**Airspace Change Proposal  
Stage 2a**

**London Southend Airport Design  
Principle Evaluation - Annex**

London Southend Airport FASI(S)

CPJ-5641-RPT-020 V1.0

Figure 1: Departure Options Runway 05 - Northeast

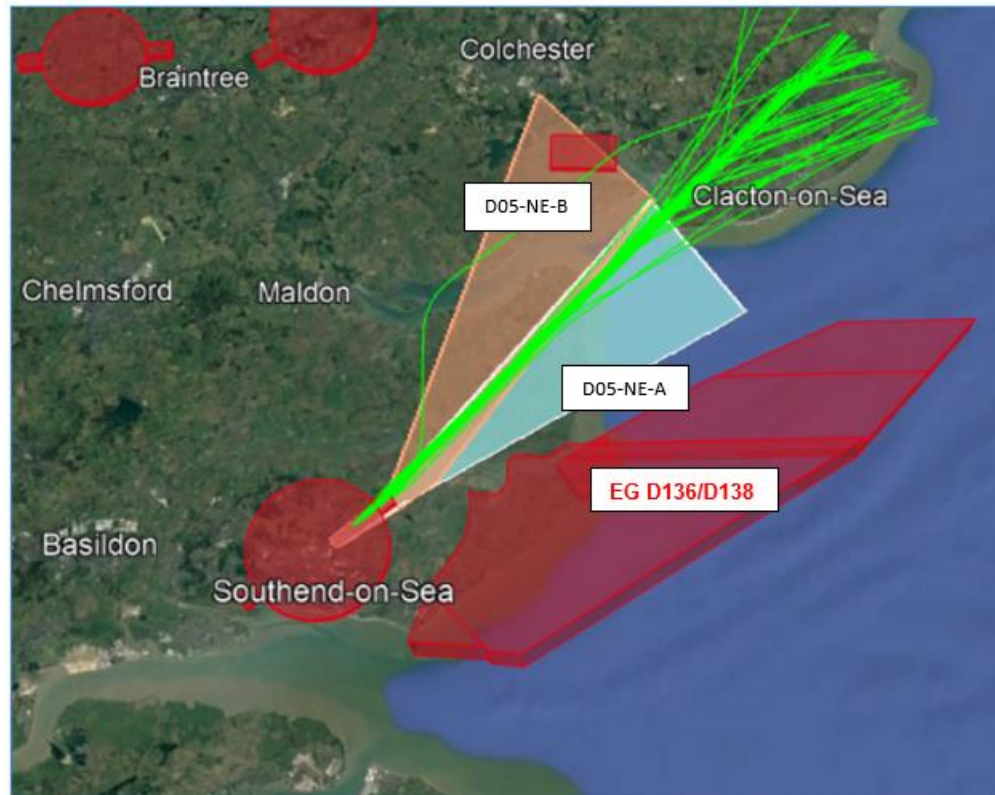
‘DP2/DP3 swathe appears to include Southminster so should be assessed same as D05-NE-B. Also appears to include Burnham-on-Crouch, which appears larger than Southminster.’

‘No; the departure D05 NE-A Aircraft should be encouraged to have a maximum gradient of climb, utilising maximum performance, ensuring thrust reduction altitude is at 1500’ and acceleration altitude is 3,000’ or preferably 4,000 which will then ensure a minimum noise impact on Great Stambridge, aircraft are then to be kept mid-way between Ashingdon and Canewdon avoiding the major population areas of these villages, and being at the base of London airspace by the river Crouch, reducing the noise footprint at Burnham. How does the current proposal meet (Design principle 9, page 4 of the presentation). DP9. The current actual green lines take aircraft over the populated areas of the area which is unnecessary however with the reduction of VOR and increased RNP the requirement to route to CLN will be reduced allowing a more varied departure routing and aircraft to be higher when over local villages.’

‘No, 3,4,5 – Flight path is over Crouch and Roach Estuaries SPA and Ramsar site, Blackwater Estuary SPA and Ramsar, Essex Estuaries SAC, Colne Estuary SPA and Ramsar, and Dengie SPA and Ramsar which could have significant impacts on the interest features of these sites including disturbance from low flight altitudes and increased noise, bird strikes, as well as the potential for additional emissions and pollutants’

‘No; Looking at runway 05 NE-A DP4 have 5 possible conflict areas, with a bit of tweaking and use of RNP (RNAV) positions the overflight of populated areas 2,3 and the bird sanctuary 5 could be completely avoided, certainly the aircraft could be a lot higher overpopulated areas if departure option 2 described above is stated in the text on the departure routes. Aircraft then don’t have to follow the green tracks to CLN before turning. TUGPO TRIPO then enroute could be the solution. Overflight of the bird sanctuary at Wallasea could easily be at or above 6,000’ if departure option 2 described above would be stated.’

**LSA agree and we have amended our assessment of DP2 and DP3.** ‘No; Swathe A indicates that it would overfly the holiday park at Mersea Island, this is incorrectly captured in the table below.’

**LSA agree and we have amended our assessment of DP2 and DP3.**

**This is welcome feedback from our stakeholder, however the detail given at this stage of the process is more in depth than the current assessment we are carrying out. Further in the ACP process, when we reduce our options and refine the swathes to more concise routes, we will consider and evaluate climb gradients and accurate tracks.**

**LSA agree and we have amended our assessment of DP4.**

**This is welcome feedback from our Stakeholder, however the detail given at this stage of the process is more in depth than the current assessment we are carrying out. Further in the ACP process, when we reduce our options and refine the swathes to more concise routes, we will consider and evaluate climb gradients and accurate tracks.**

Figure 7: Departure Options Runway 05 - South/ Southeast

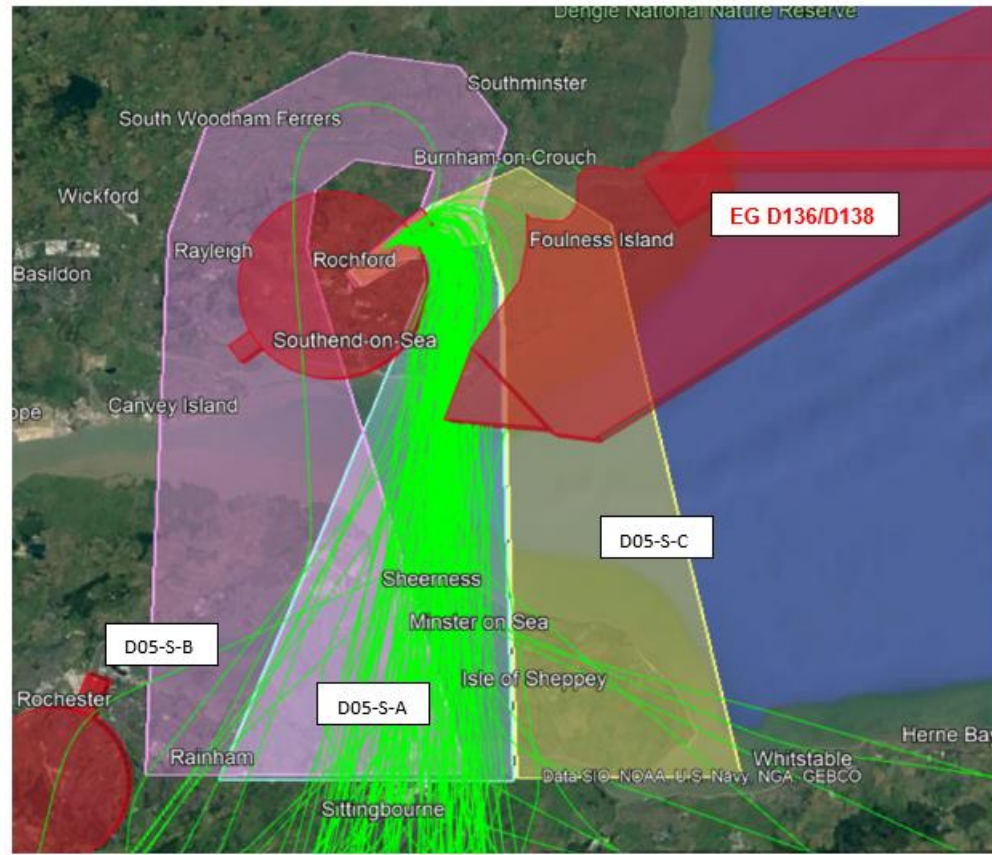
‘05 S B used to be the only departure procedure for runway 05, which was replaced by 05 S A few years ago with aircraft departing 05 and flying over the villages of Stonebridge, Little and Great Wakering Barling Shoeburyness in the climb but restricted on altitude by London ATC both S A and S B should be replaced by S C avoids flying over the population and wildlife areas therefore making the departures safer, but would involve coordination with the military DA authorities, as there will be scheduled services using this route pre planning of their activities wouldn’t be an issue avoiding the departure times of aircraft.’

'05 S B used to be the only departure procedure for runway 05, which was replaced by 05 S A a few years ago with aircraft departing 05 and flying over the villages of Stonebridge, Little and Great Wakering Barling Shoeburyness in the climb but restricted on altitude by London ATC both S A and S B should be replaced by S C avoids flying over the population and wildlife areas therefore making the departures safer, but would involve coordination with the military DA authorities, as there will be scheduled services using this route pre planning of their activities wouldn't be an issue avoiding the departure times of aircraft.'

‘05 S B used to be the only departure procedure for runway 05, which was replaced by 05 S A few years ago with aircraft departing 05 and flying over the villages of Stonebridge, Little and Great Wakering Barling Shoeburyness in the climb but restricted on altitude by London ATC both S A and S B should be replaced by S C avoids flying over the population and wildlife areas therefore making the departures safer, but would involve coordination with the military DA authorities, as there will be scheduled services using this route pre planning of their activities wouldn’t be an issue avoiding the departure times of aircraft.’

Figure 11: Departure Options Runway 23 - Northeast

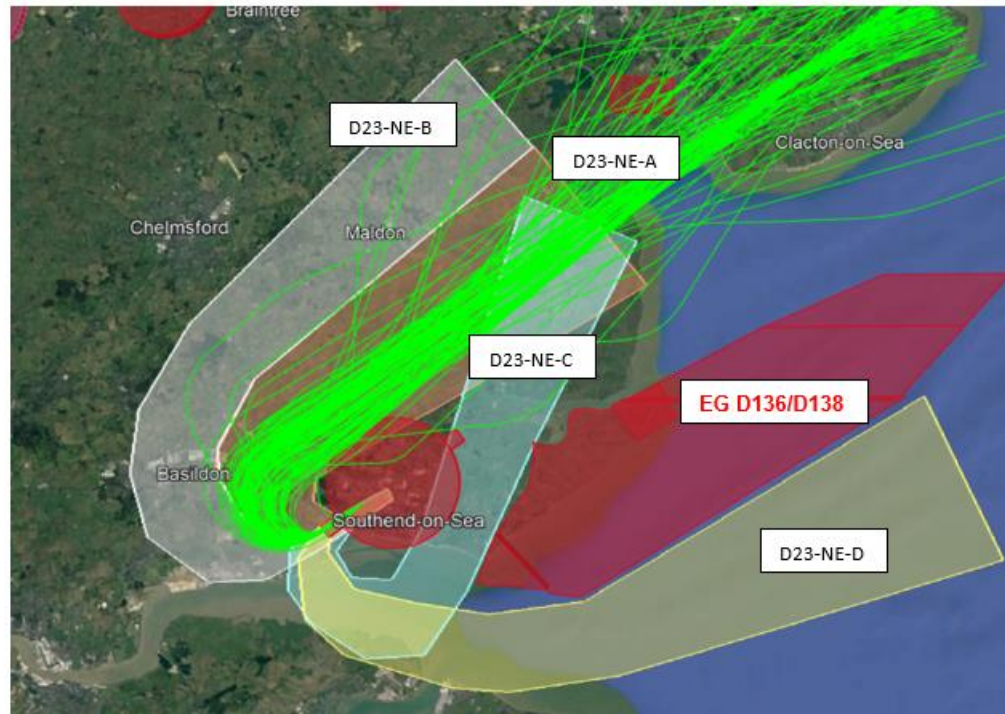
'No; Departures 23 Northeast D23 NE A DP 2 Over flight DP 3 Noise DP 4 Tranquillity procedure to be re written to ensure the aircraft are 1,000' higher at the point before they turn and change acceleration altitude to 4000.'

‘No; Departures’ 23 Northeast D23-NE- B DP 2 Over flight DP 3 Noise DP 4 Tranquillity procedure to be re written to ensure the aircraft are 1,000’ higher at the point before they turn and change acceleration altitude to 4000’ ensure the aircraft climb straight ahead to 4000’ or 3 nm before turning right then between Canvey Island and South Benfleet then North bound when passing 5000’ or bowers Gifford follow the A130 northbound.’

Figure 40: Arrival Options Runway 23 - South & East

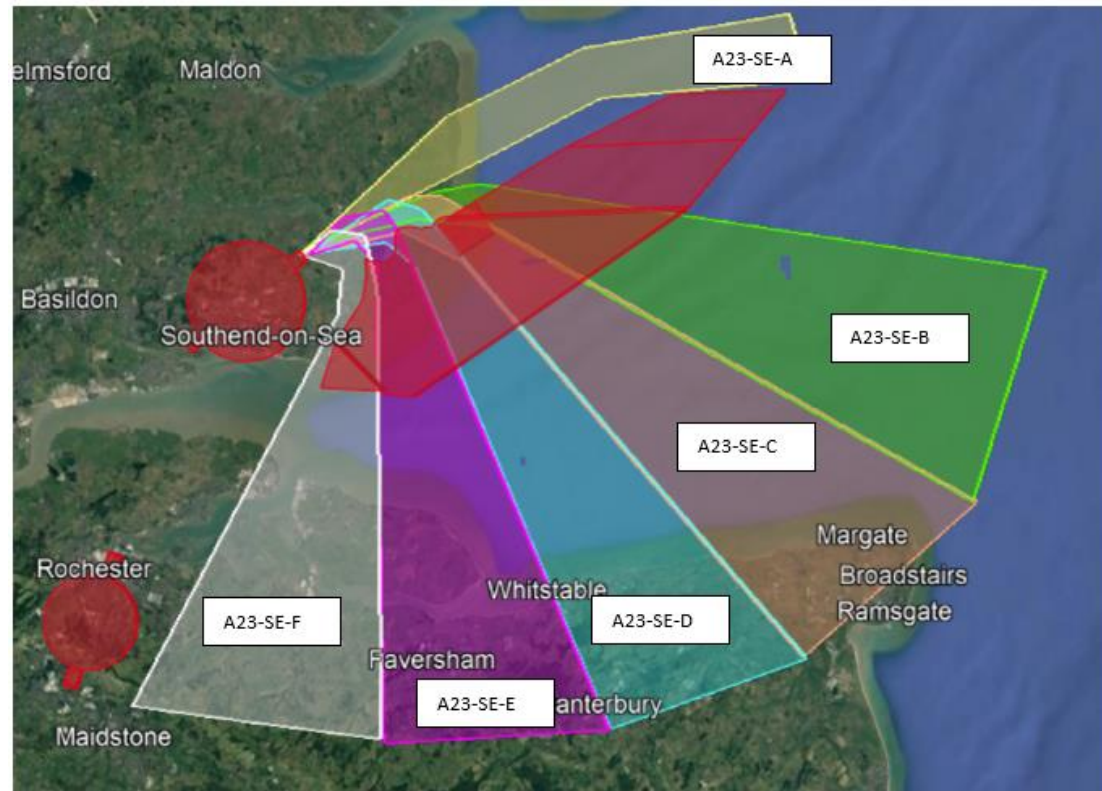
‘Arrivals 23 via e and f over the built-up areas and flying level isn’t a good plan, re design these to avoid the built-up areas isn’t difficult.’

‘Arrivals 23 via e and f over the built-up areas and flying level isn’t a good plan, re design these to avoid the built-up areas isn’t difficult.’

**Should this option be progressed, this comment will be addressed and considered later in the ACP process when we reduce our options and refine the swathes to more concise routes. We will then consider and evaluate climb gradients and accurate tracks.**
